CIPHERLAB CO., LTD.

## **CipherLab Announced Material Change of 1166/1266 Bluetooth Scanners from TPR to TPU and Engine Upgrade of 1266 Bluetooth Scanner**

1166/1266

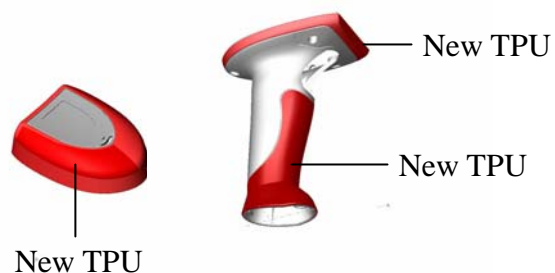
To provide better products to its customers, CipherLab changed material from TPR to TPU for Bluetooth scanner 1166 (starting from serial number AF6006495) and 1266 (starting from serial number AG6003574).

TPU (Thermoplastic Polyurethane) is a non-toxic and environmental friendly material, and it offers unmatched abrasion and wear-resistance comparing to the current TPR.

Though the material will be changed, the appearance and functions will not be affected. Field test for three months had been done through the assistance of our partner Welcom in Japan.

New TPU

(Red color is only for marking the position of material change).
